#### IOWA DEPARTMENT OF NATURAL RESOURCES LAND & WATERS BUREAU WALLACE STATE OFFICE BUILDING

DAM MITIGATION

PROJECT NUMBER: 10-03-10-01

10/24/2018 ADDENDUM #2

B.01

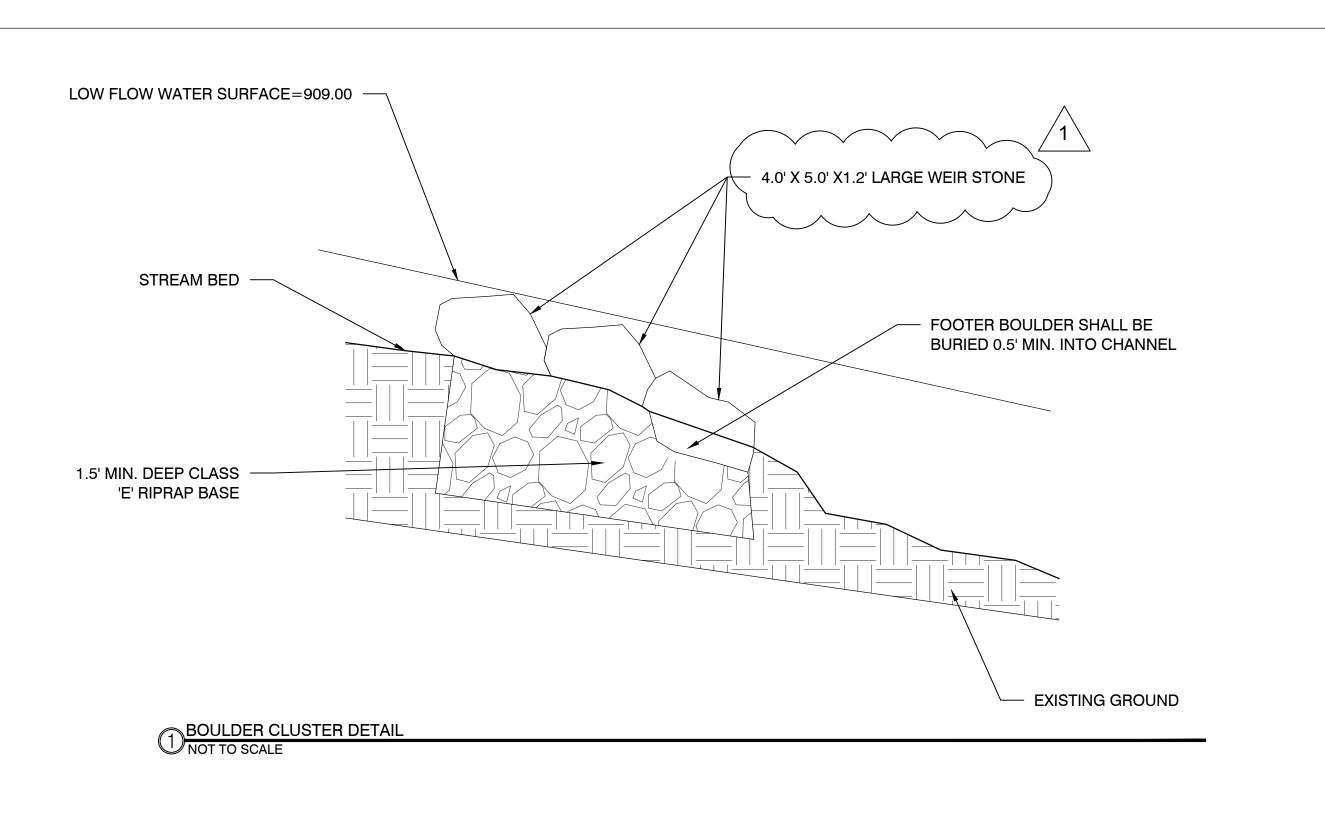
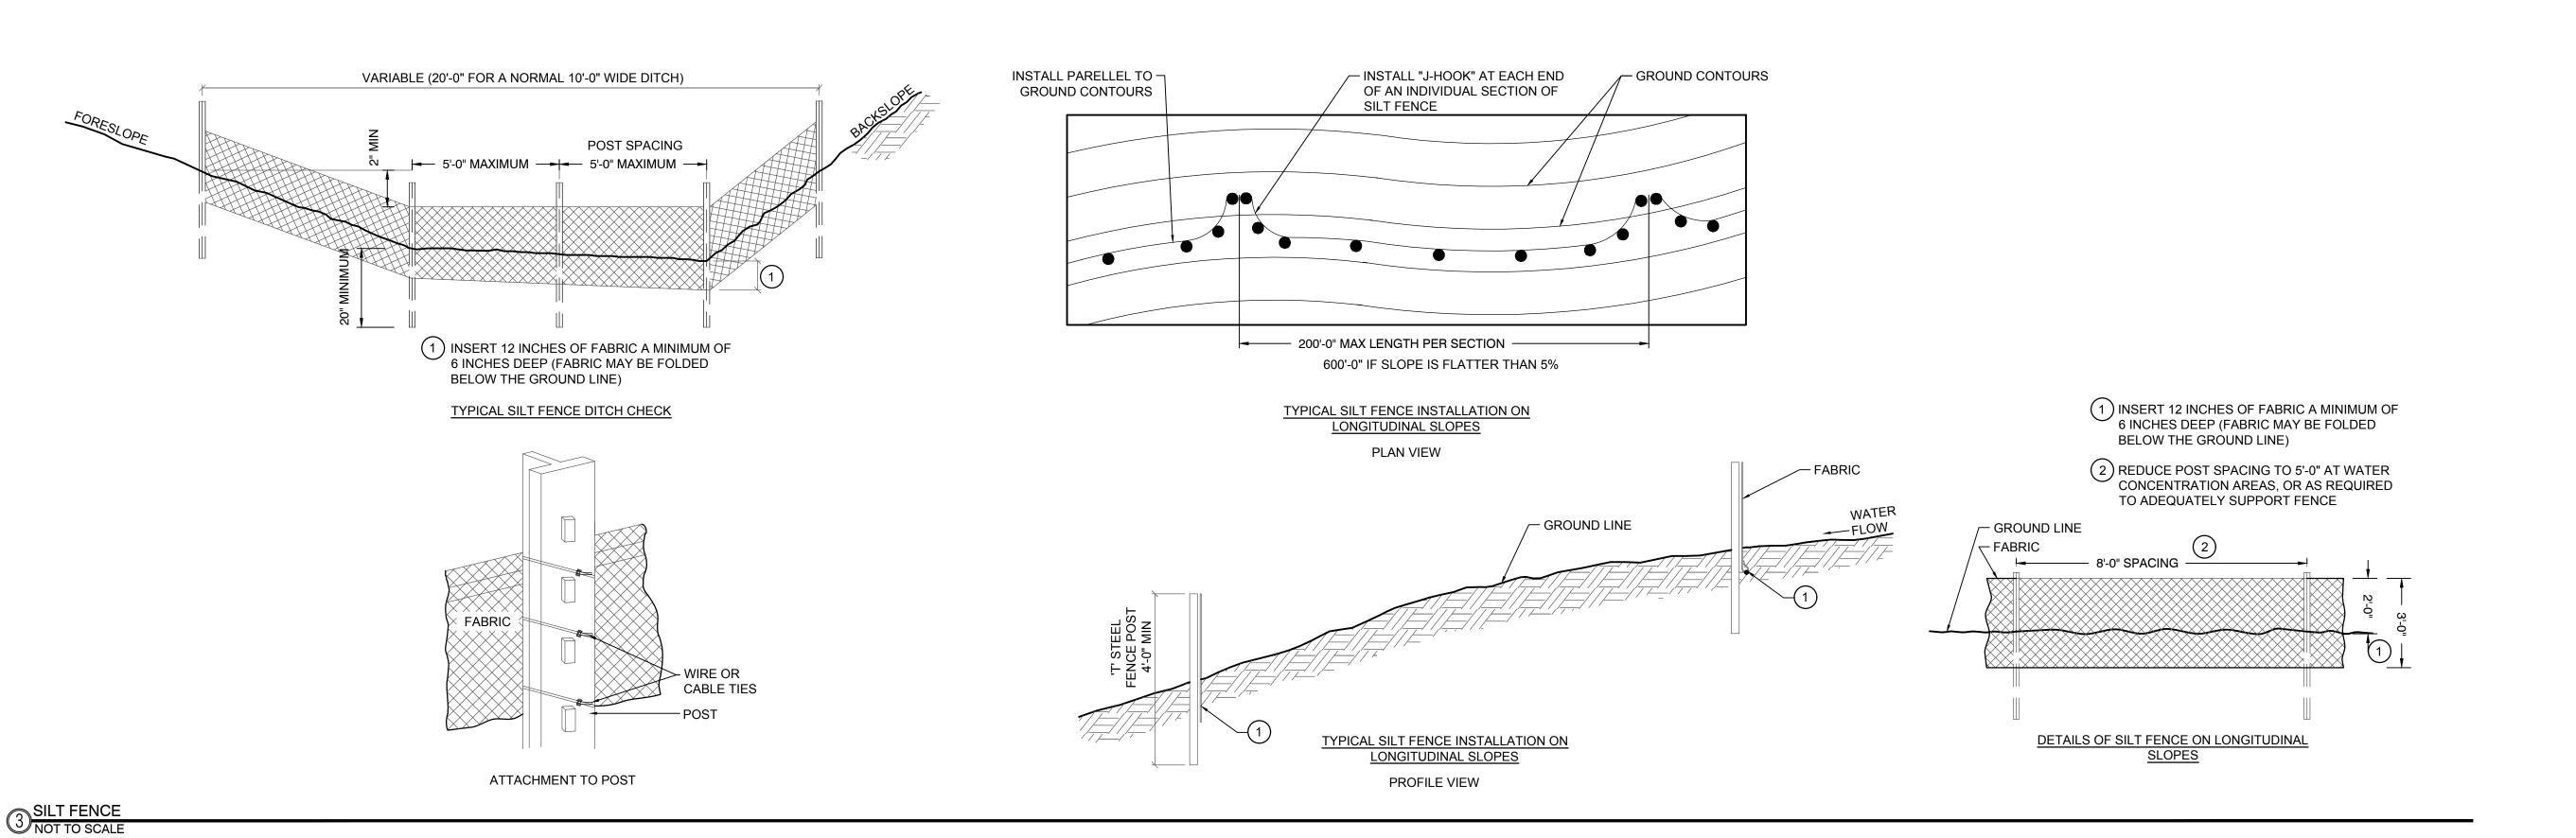
- A. The following plan sheets have been revised and are attached to this addendum:
  - B.01 Details Updated Boulder Cluster Detail
  - C.01 General Notes Updated Quantities table and Estimate Reference Information table
